UNITED STATES OF AMERICA  
BEFORE THE NUCLEAR REGULATORY COMMISSION

| Continued Storage of Spent Nuclear Fuel | ) | Docket No. 2012-0246 |

**DECLARATION OF DR. ARJUN MAKHIJANI  
REGARDING THE WASTE CONFIDENCE PROPOSED RULE  
AND DRAFT GENERIC ENVIRONMENTAL IMPACT STATEMENT**

Figure 1. Burnup trends for PWR and BWR reactors in the United States (Reproduced from IAEA 2011, Fig. 6 (p. 9), with note: Courtesy of Energy Resources International)

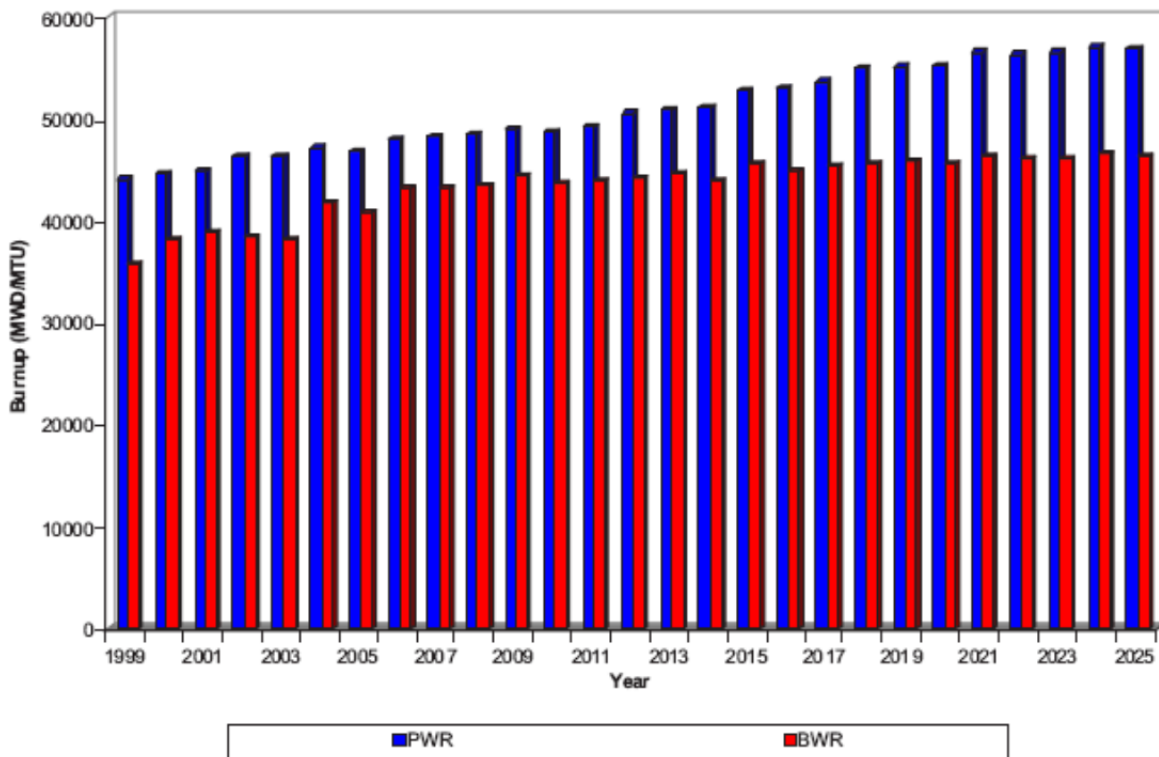
Figure 1 shows the trends in burnup for PWRs and BWRs. It shows that high burnup fuel (more than 45 GWd per metric ton) started being discharged from reactors only around the turn of the century. Most of this is still in spent fuel pools. Examination of high burnup spent fuel after dry storage of 15 years, as was done for low burnup Surry fuel,<sup>53</sup> is not yet possible, though some experimental work with high burnup fuel cladding has been done.<sup>54</sup>

Figure 2. Cladding outer surface oxide thickness layer versus rod average burnup (Reproduced from NWTRB 2010, Figure 20 (p.56))

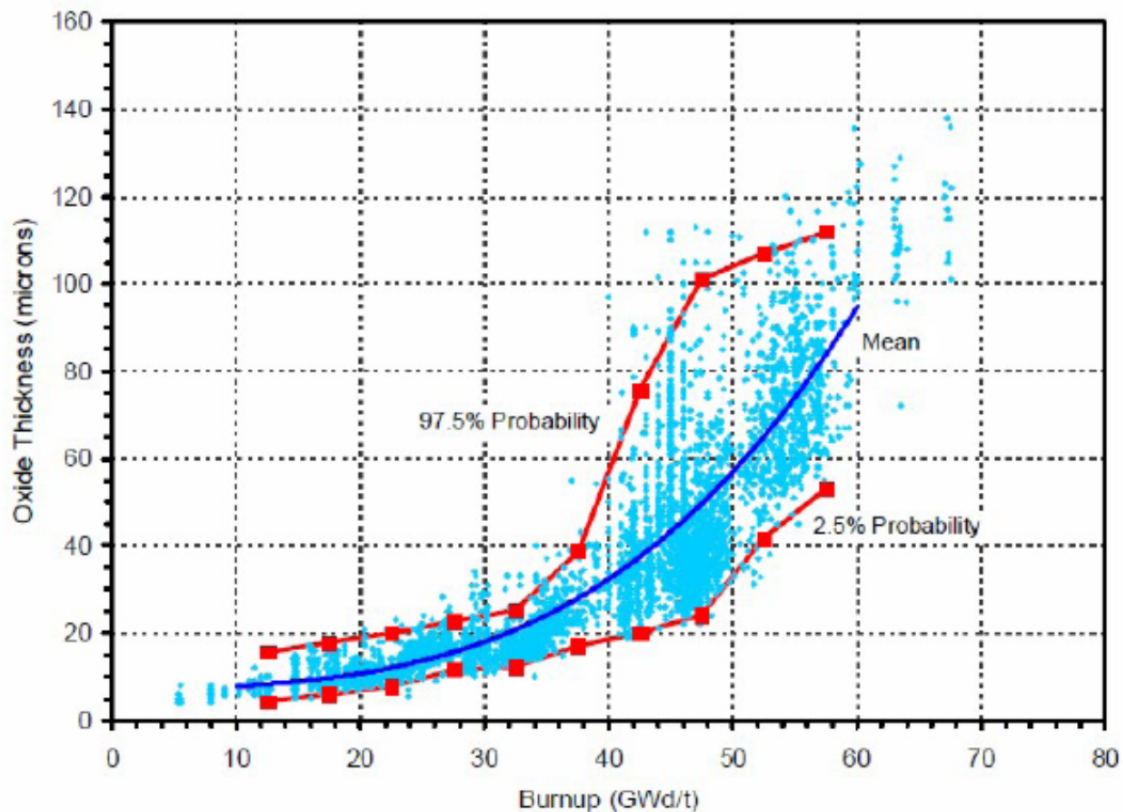
4.21. High burnup fuels also tend to build up much thicker levels of oxide during the in-reactor period as well as much higher levels of hydrogen in the cladding. Figure 2 below shows that the typical increase in outer oxide layer thickness increases from about 20 microns at 30 GWd/MTU to about 100 microns at about 62 or 63 GWd/MTU at discharge from the reactor.<sup>72</sup> Moreover, the spread in the oxide layer thickness increases with burnup, indicating that some fraction of fuel rods may be at a much greater risk of failure.

about 70 microns to 130 microns, a spread of 60 microns. In fact these data show that the *variability* in oxide layer thickness at 63 GWd/MT burnup is almost *twice as large as the maximum* thickness at 30 GWd/MT. The oxidation and hydriding in-reactor data point to (i) a higher probability of failure and (ii) more severe failures in some fraction of the rods in cases when failures occur upon prolonged spent fuel pool and dry storage for high burnup spent fuel. High oxide and hydrogen levels in cladding create a host of vulnerabilities in spent fuel, including increased brittleness upon drying, high hoop stresses, and other phenomena that could cause fuel to fail – that is, to develop cracks and fissures that are significant enough to cause release of fission products. Reasonable confidence in the integrity of spent fuel after long periods of storage would not only require examination of typical high burnup fuel rods but also the ones at the higher levels of initial degradation that are clearly indicated by currently available information of in-reactor performance.

Figure 3. Maximum Wall Thickness Average Hydrogen Content in Low-Tin Zircaloy-4 Cladding (Reproduced from NWTRB 2010, Figure 21 (p.56))

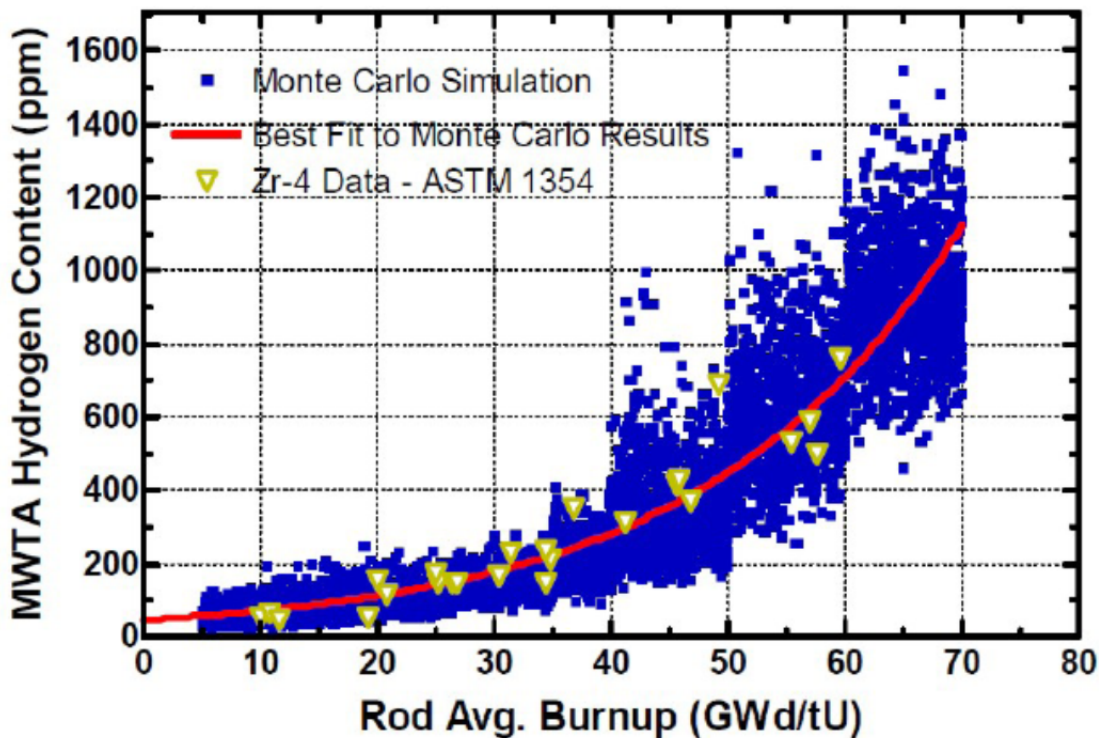
4.22. Figure 3 shows that the maximum wall thickness hydrogen content increases from 200 ppm to 800 ppm at discharge over approximately the same burnup range as in Figure 2. In both cases the variability is also much greater at the higher burnup. For instance, Figure 3 shows oxide layer thicknesses for a burnup of 30 GWd/metric ton ranging from roughly 12 microns to (at most) 35 microns – a spread of 23 microns. At 63 GWd per metric ton the thickness range from
